ADDENDUM NO. 2

March 1, 2022

**TIMOTHY BALL ELEMENTARY SCHOOL ADDITIONS, RENOVATIONS,
AND RELATED WORK
Crown Point, IN 46307**

This Addendum forms a part of and modifies the Bidding Requirements, Contract Forms, Contract Conditions, the Specifications, and the Drawings dated February 7, 2022 by Gibraltar Design. Acknowledge receipt of the Addendum in the space provided on the Bid Form. Failure to do so may subject the Bidder to disqualification.

UNIT "A" ELECTRICAL FIRST FLOOR LIGHTING PLAN
SCALE: 1/8" = 1'-0"

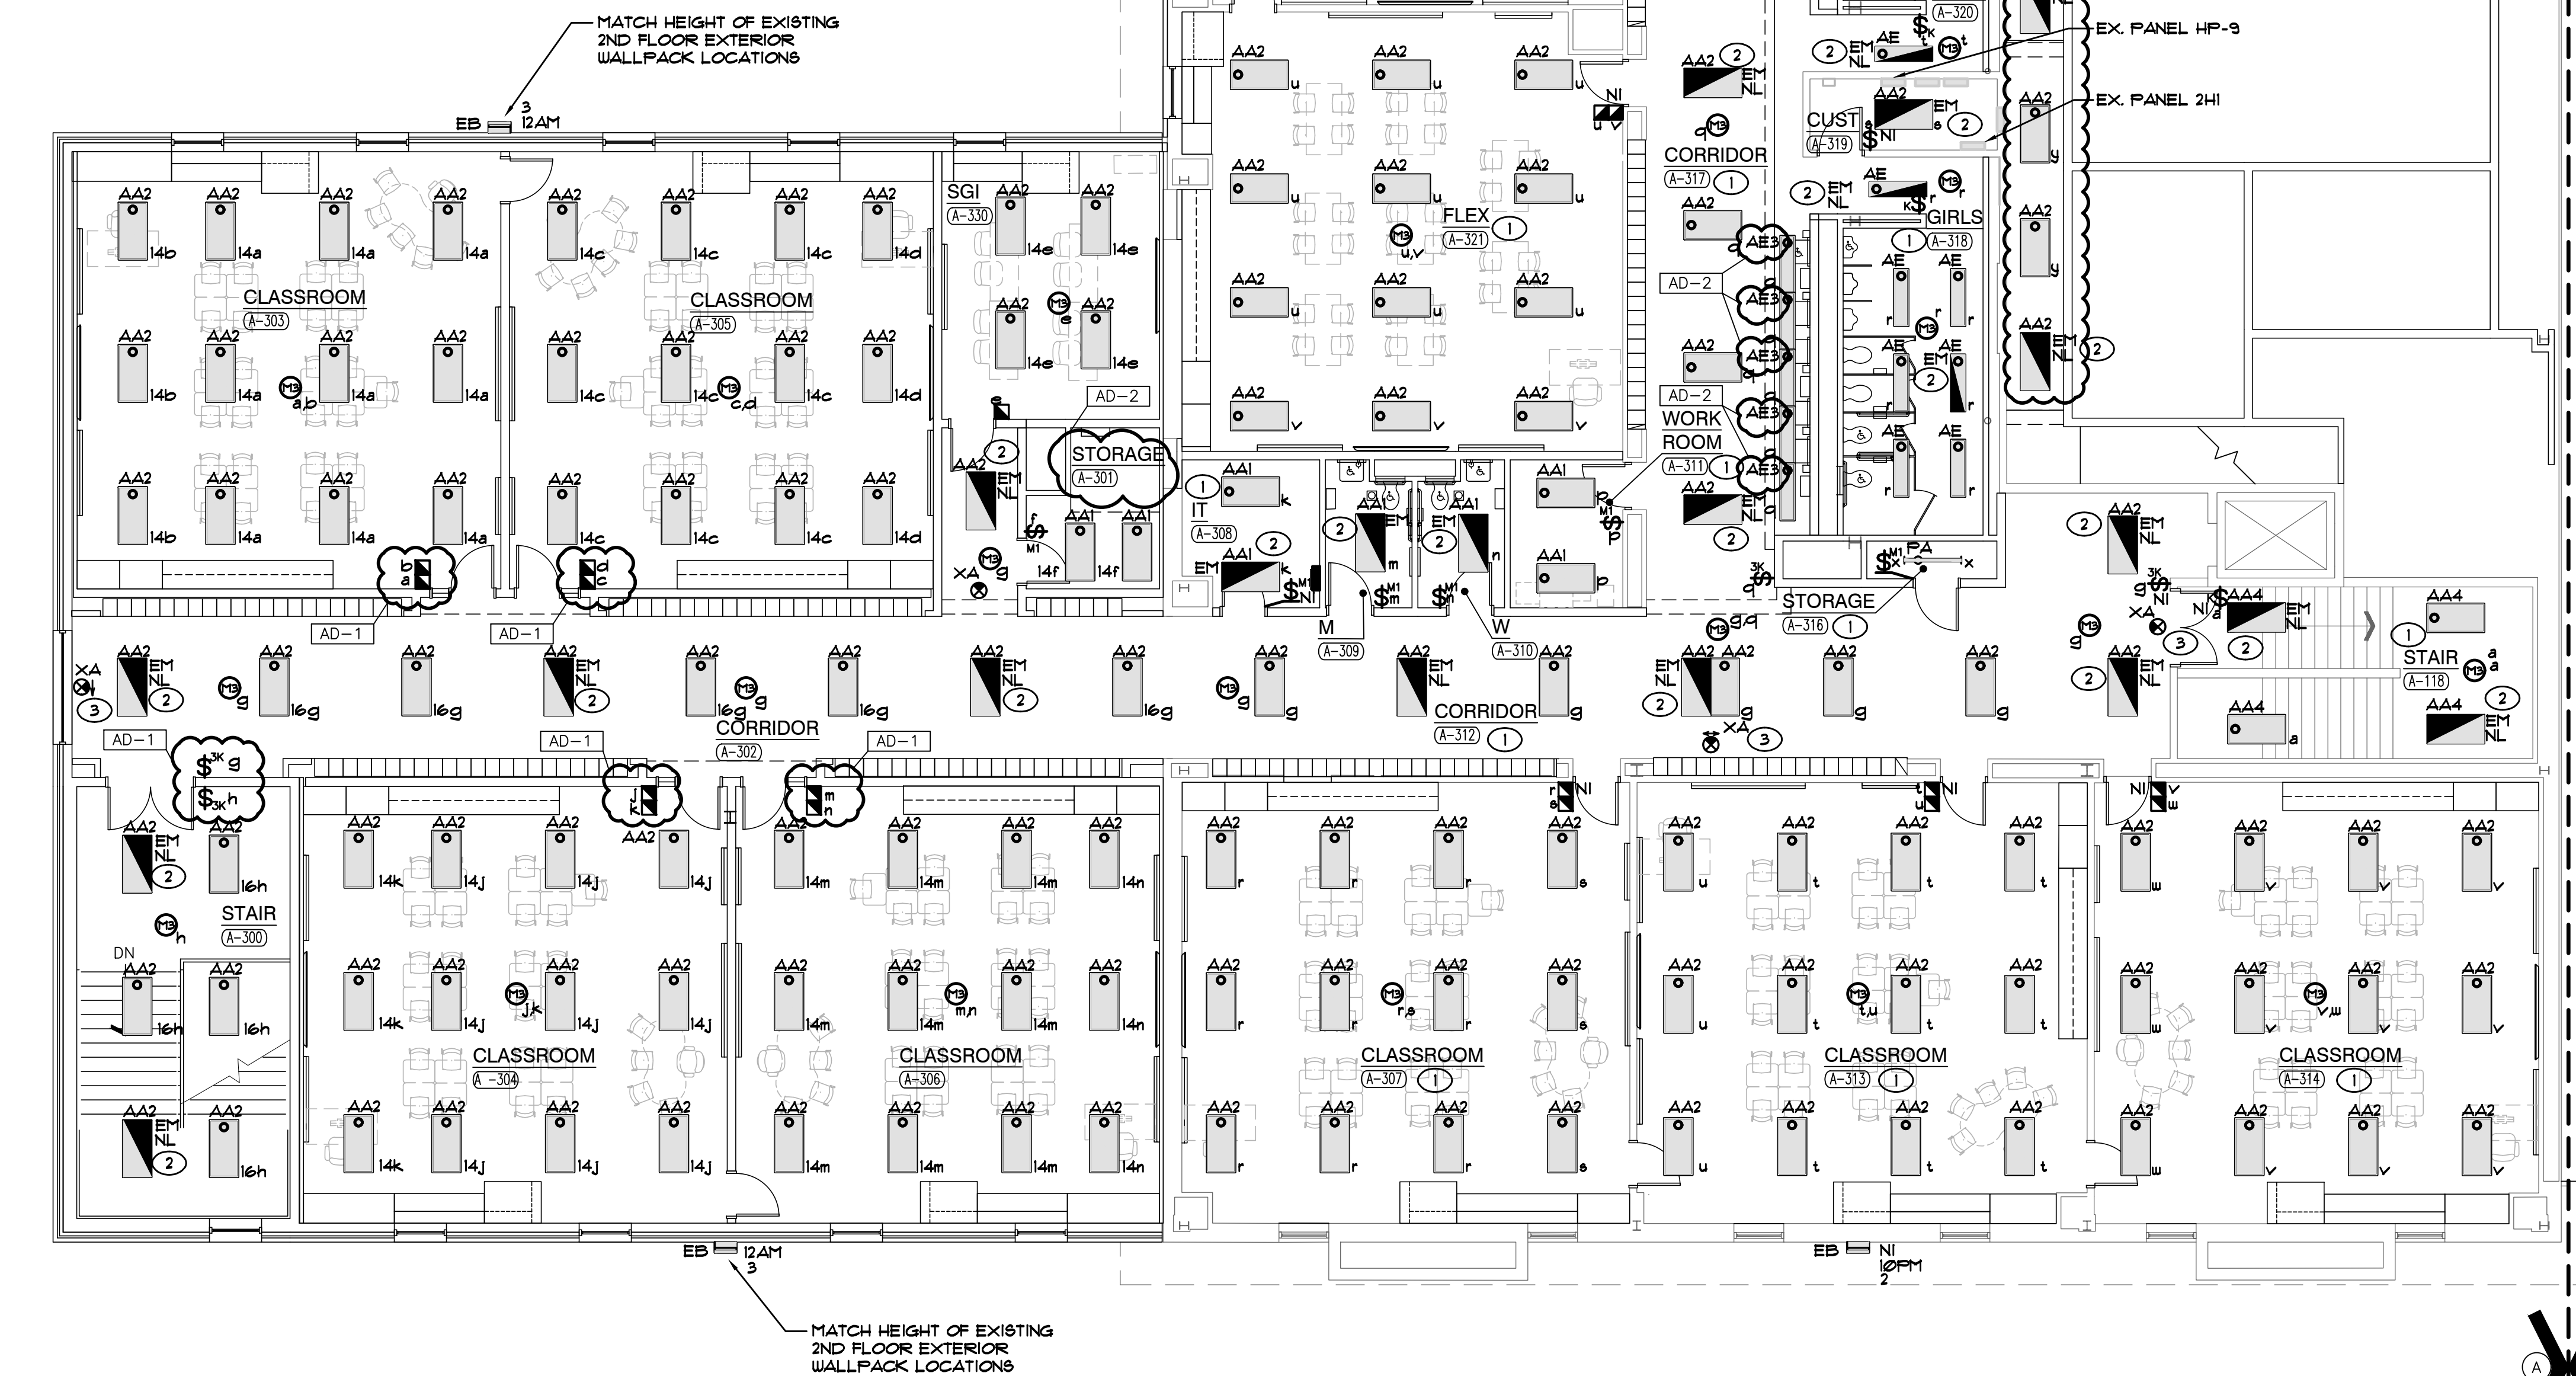
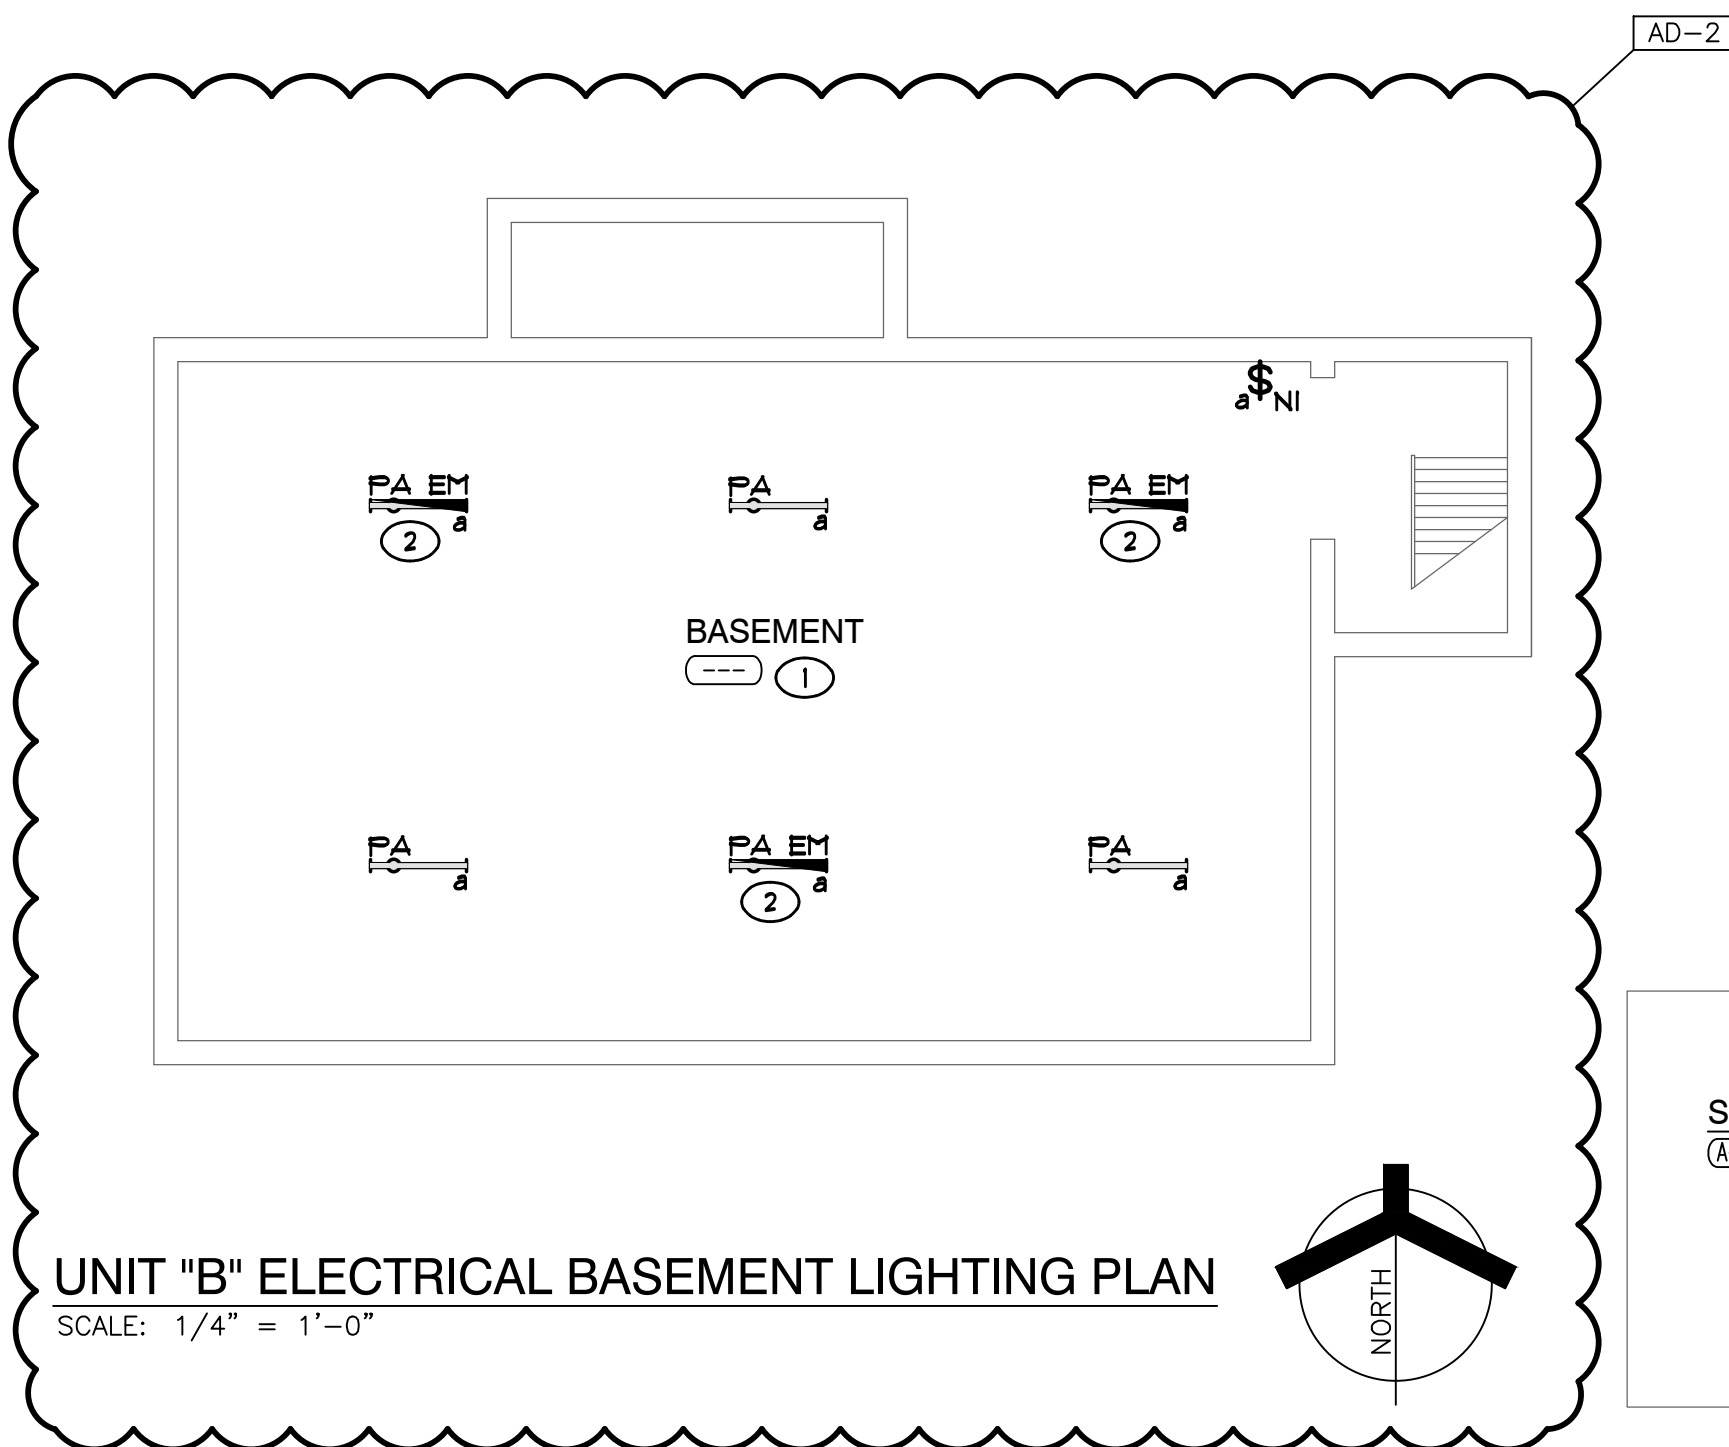
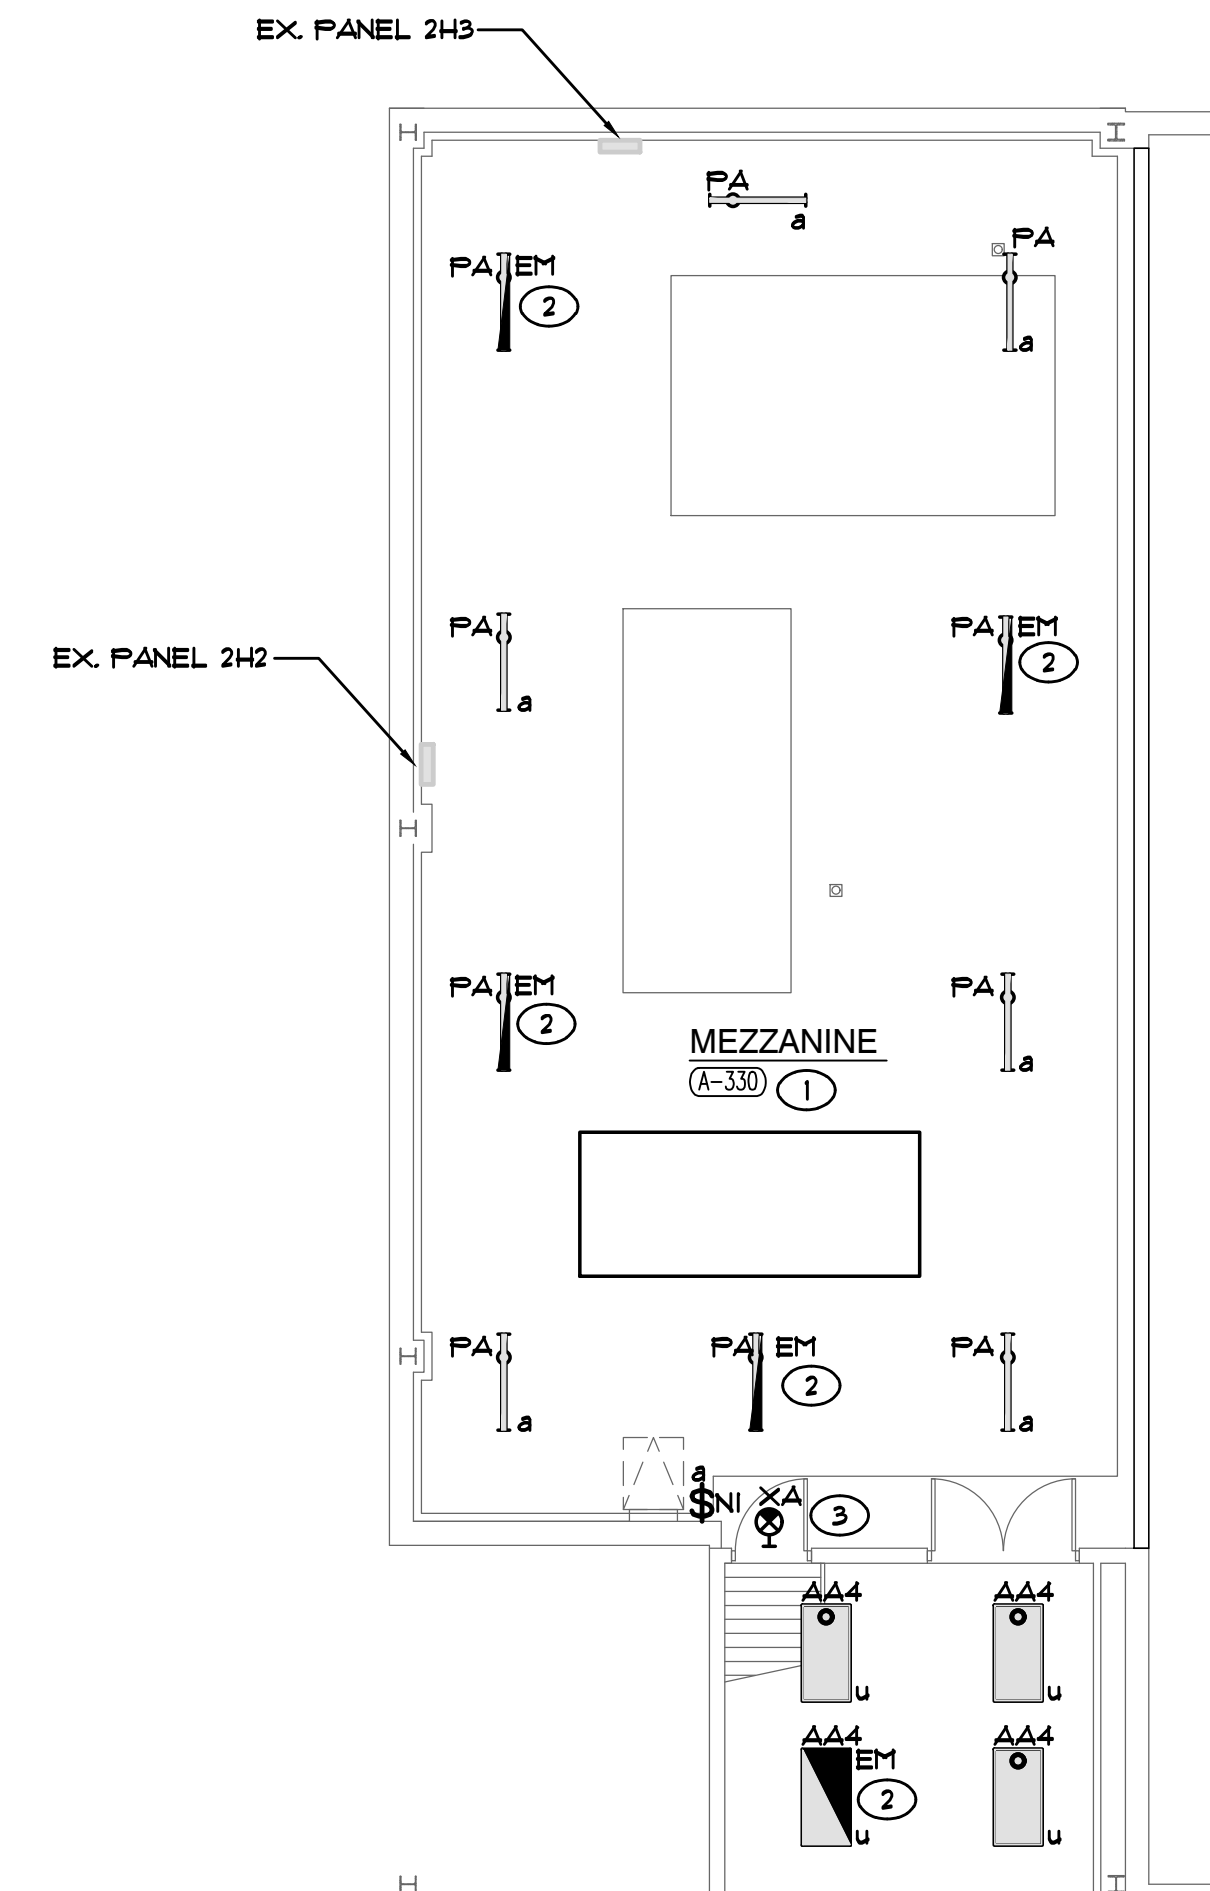
37. Sheet EL101

- A. Refer to revised, full size drawing, included in this Addendum, for the following revisions:
 - 1. Revised lighting fixture types.
